February 11, 2008
357891

RE: Data Response, Set 1B
Ivanpah Solar Electric Generating System (07-AFC-5)

Ivanpah Solar Electric Generating System (ISEGS)

Data Response, Set 1B

CONCEPTUAL
HELIOSTAT AREA PLAN
DRAWING 1 OF 8

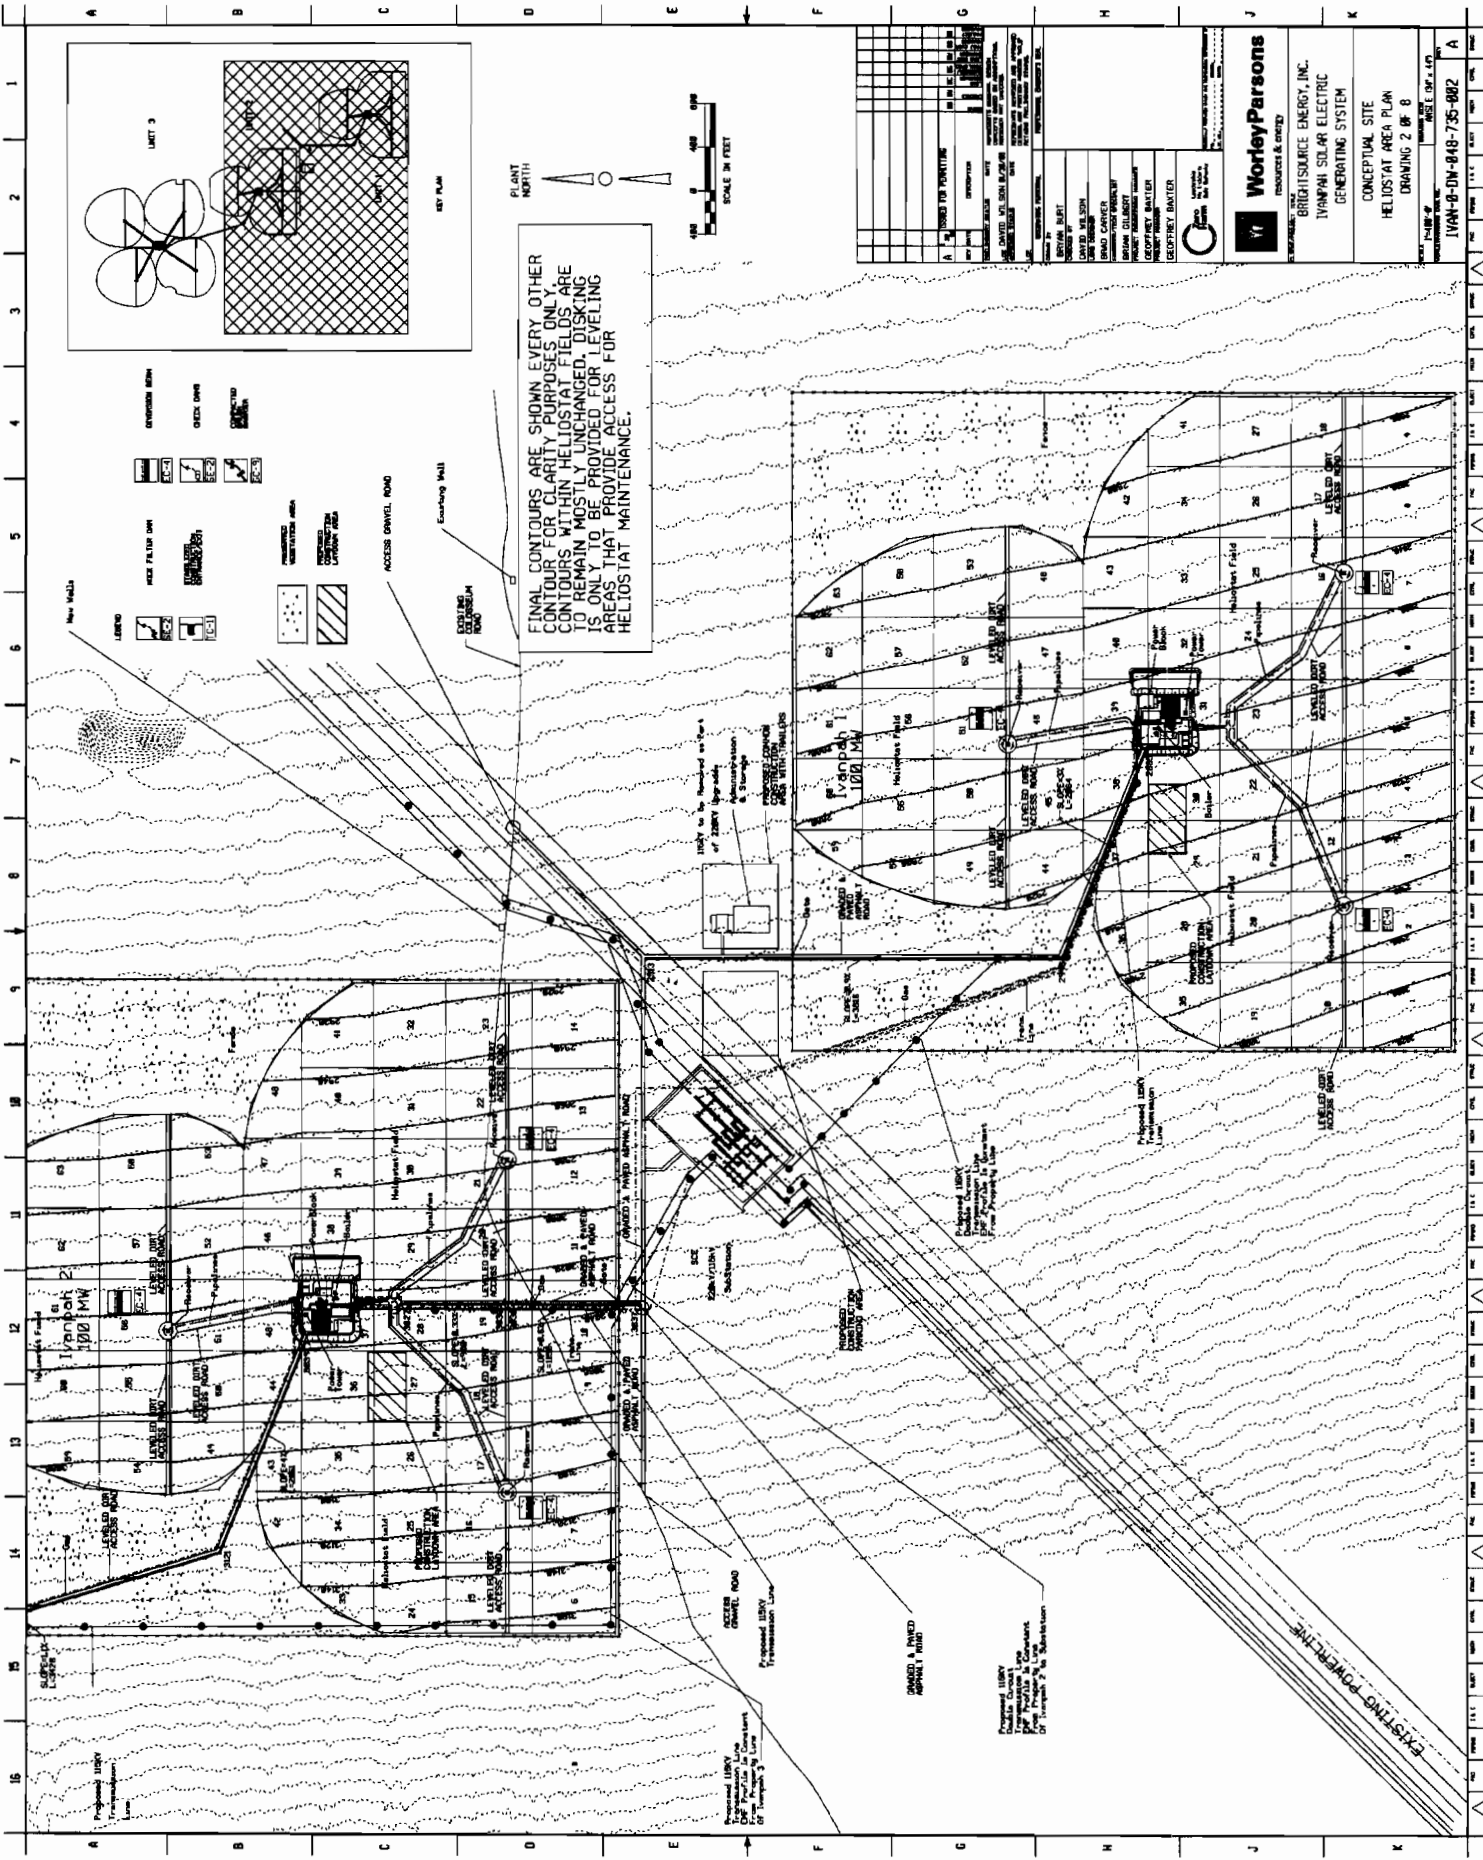
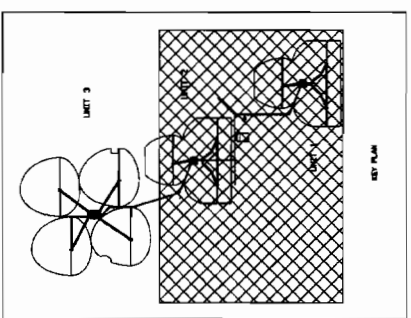
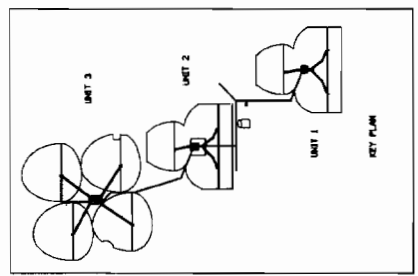
6. Describe and plot spoils storage location, confirming the location would be located within the proposed project footprint or an added acreage.

26. Provide a graphic and description of areas of the site that will be graded and areas where root systems will be left in place, and indicate other areas of ground disturbance.

Response: The spoil storage areas have been designated as shown on drawings Ivan-0-DW112-735-003, Ivan-0-DW-048-735-004 and Ivan-0-DW-048-735-005 (the eight conceptual drawings are provided at the end of this section). Spoil storage areas are to be sited adjacent to each power block located within the proposed project footprint. A brush barrier consisting of native vegetation is to be installed down slope of each spoils storage location to promote sediment deposition.

Response: See drawings Ivan-0-DW-048-735-001 through Ivan-0-DW-048-735-007 (following Data Response 6). Grading is to be performed only within each of the power block areas, power block connecting road, and re-aligned Colosseum Road. Within the heliostat arrays the surface vegetation is to be removed and the root system is to remain. The proposed dirt access roads within the heliostat arrays will be leveled if required (minor cuts and fills) and only to the extent that minimal access is provided for heliostat installation and maintenance. Drawings Ivan-0-DW-048-735-006 and Ivan-0-DW-048-735-007 (following Data Response 6) have been created to provide

WorleyParsons resources & energy	
BRIGHTSOURCE ENERGY, INC. IVANPAH SOLAR ELECTRIC GENERATING SYSTEM	
TYPICAL HELICOST FIELD CONCEPTUAL GRADING, DRAINAGE & EROSION CONTROL PLAN DRAWING 7 OF 8	
DATE: 11/17/11	SCALE: (3" = 1')
MAN-0-DW-048-735-007

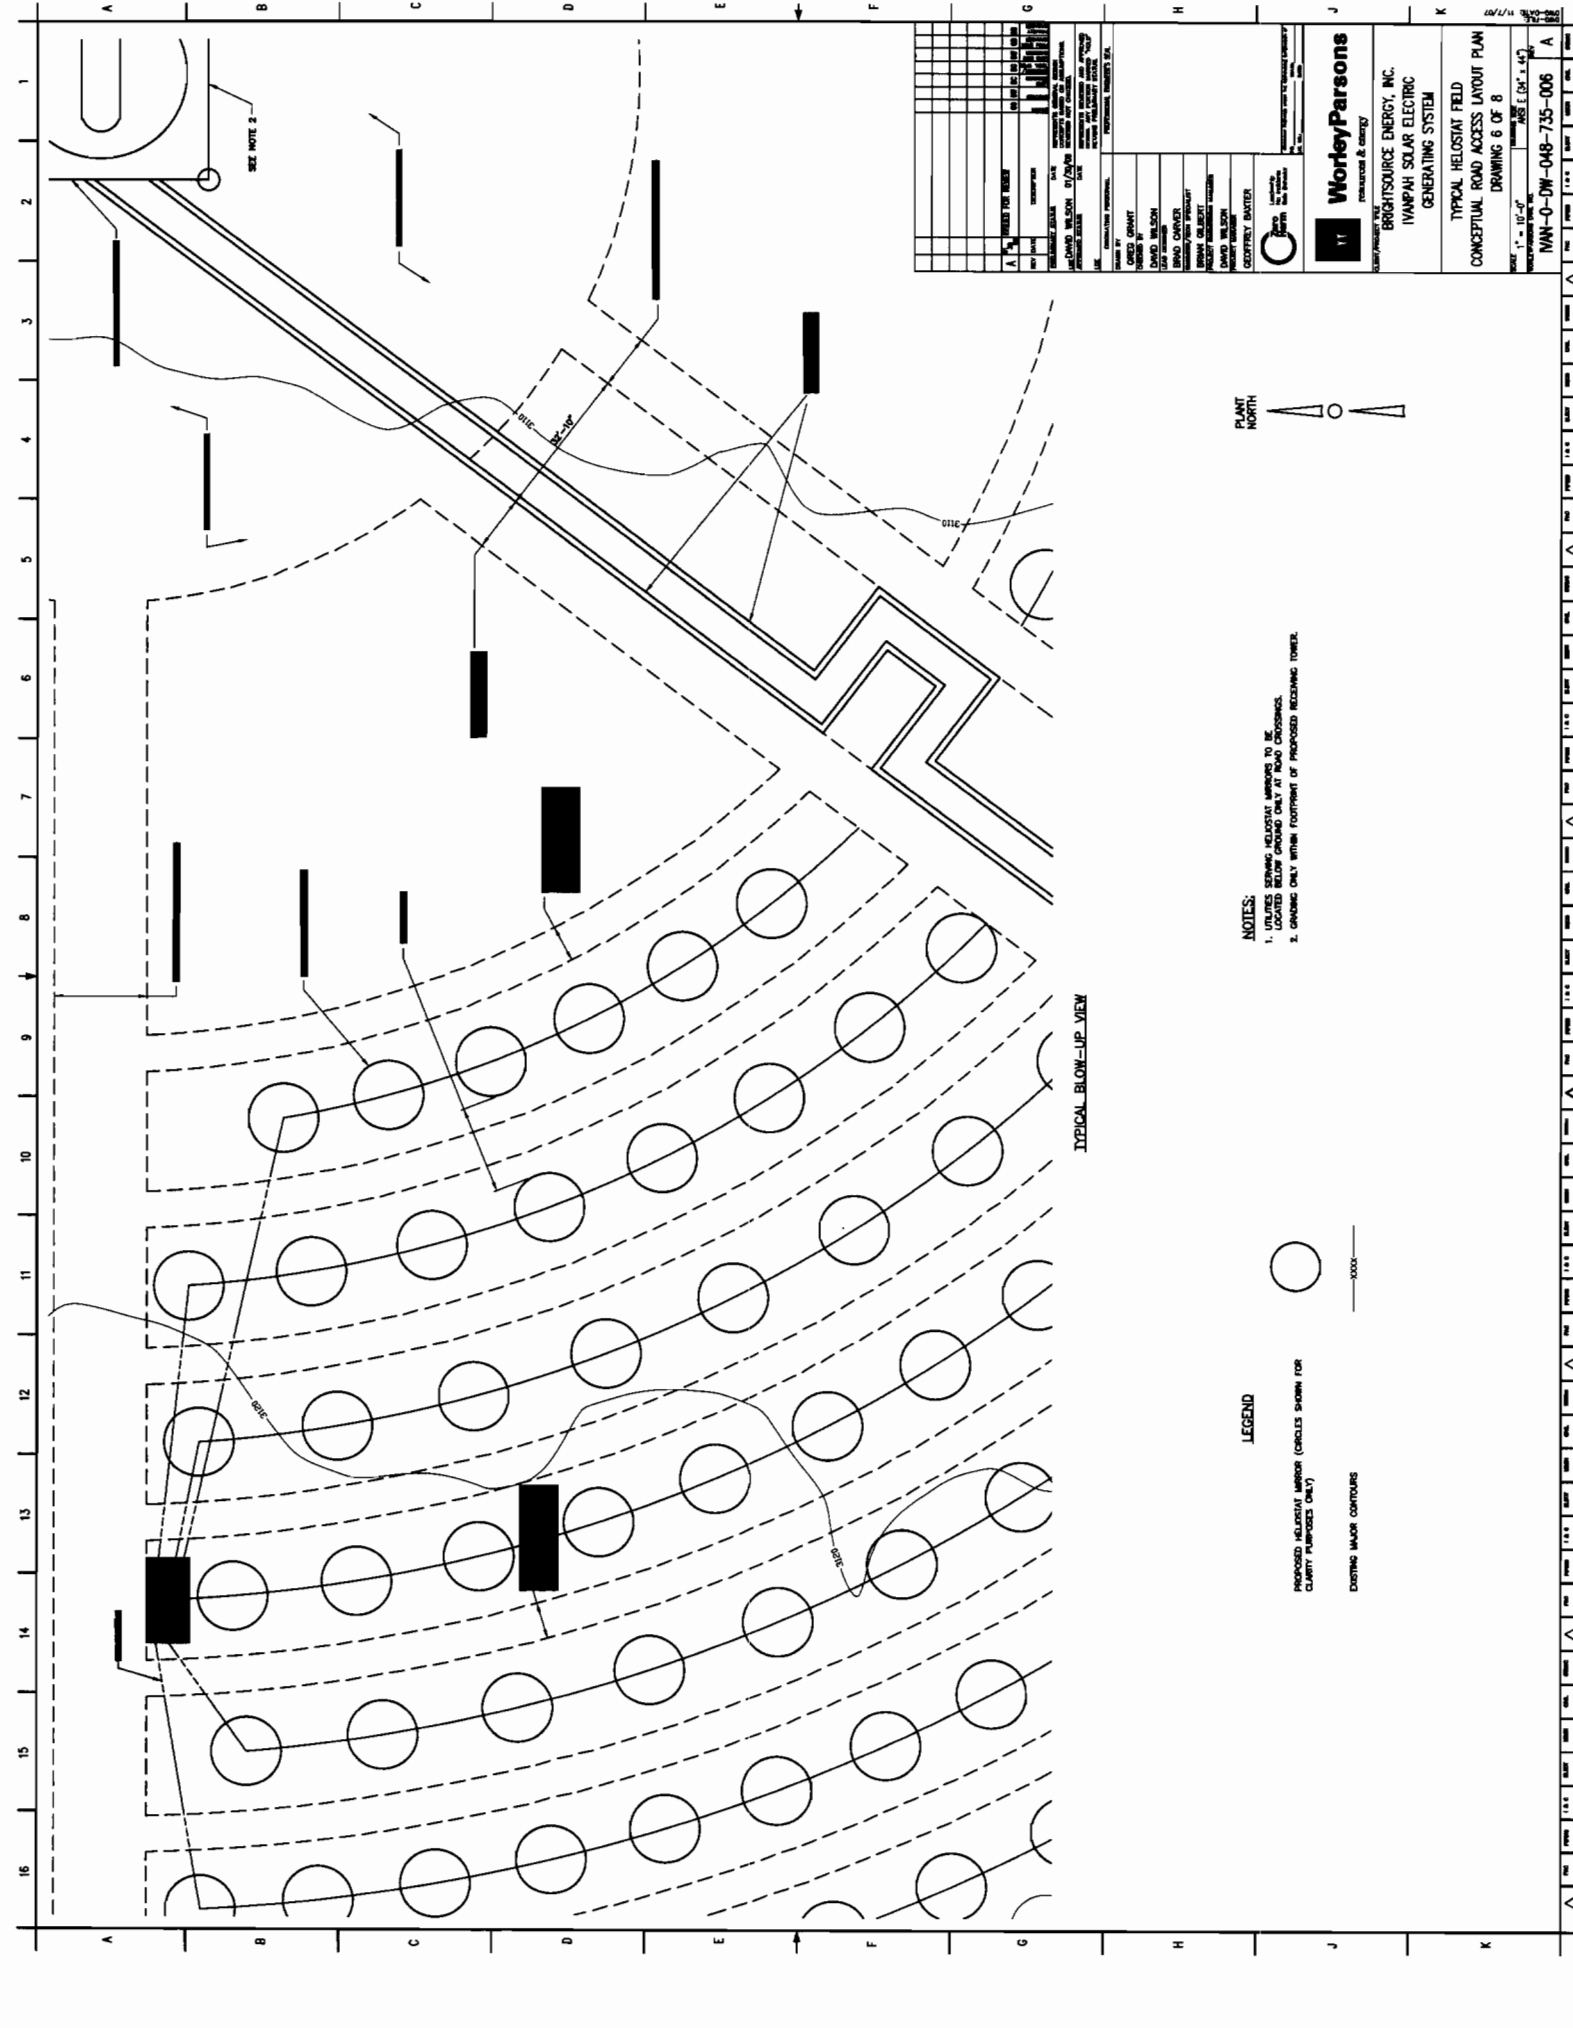
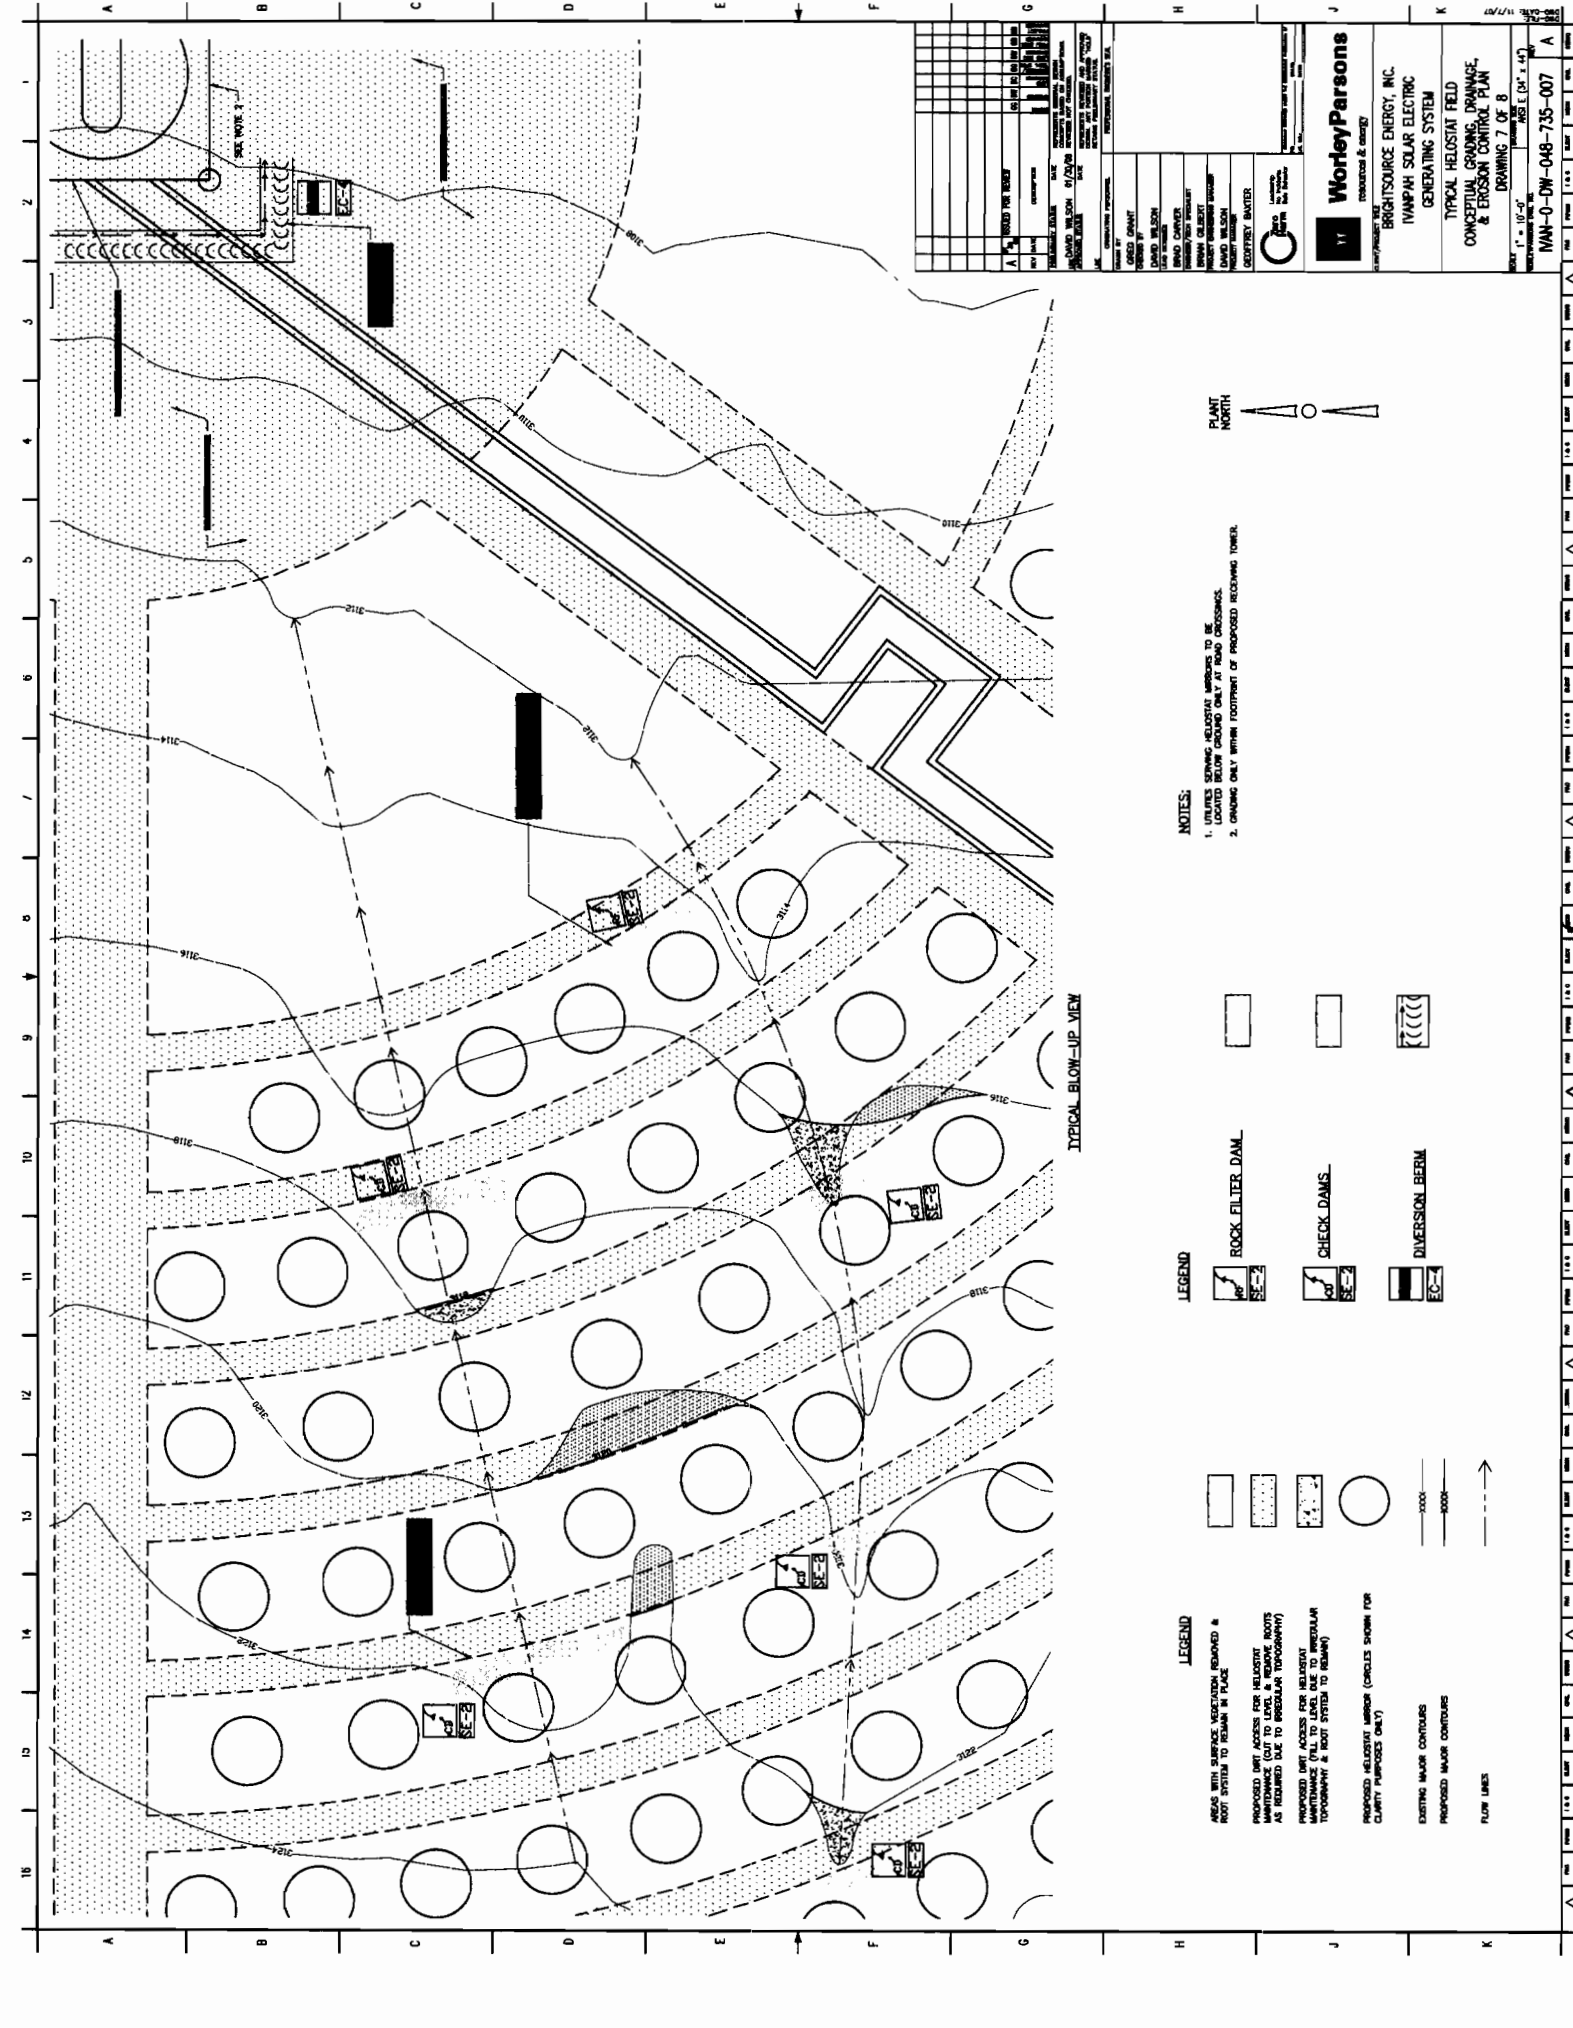
54. Provide an appropriately scaled detailed drawing of the location of all project access routes and indicate whether these are paved, graveled, or graded. This should include the access routes to and between the heliostat mirrors.

Response: The location and types (paved, graveled or graded) of project access routes have been provided in project drawings Ivan-0-DW-048-735-001 through Ivan-0-DW-048-735-007 (following Data Response 6). Roads connecting all three power blocks will be graded and paved including the re-routed Colosseum Road. The proposed dirt access roads within the heliostat arrays will be leveled if required (minor cuts and fills) and only to the extent that minimal access is provided for heliostat installation and maintenance. Drawings Ivan-0-DW-048-735-006 and Ivan-0-DW-048-735-007 have been created to provide additional clarity regarding typical areas of disturbance within the heliostat array fields.

Response: Rock filters and check dams will be strategically placed throughout the project site to provide areas for sediment deposition and promote sheet flows of stormwater. Where available, native materials (rock and gravel) are to be used for the construction of the rock filter and check dams. Periodic maintenance will be conducted as required after major storm events and when the volume of material behind the dams exceeds 50 percent of the original volume. Diversion berms will be positioned on the uphill slope of each receiver tower to catch stormwater and re-direct it before dispersal as sheet flow. Rock filters and check dams are not intended to alter drainage patterns but are intended to minimize soil erosion. A detailed drawing of proposed rock filters dams, check filter dams and local berms has been provided (see Ivan-0-DW-048-735-007, following Data Response 6).
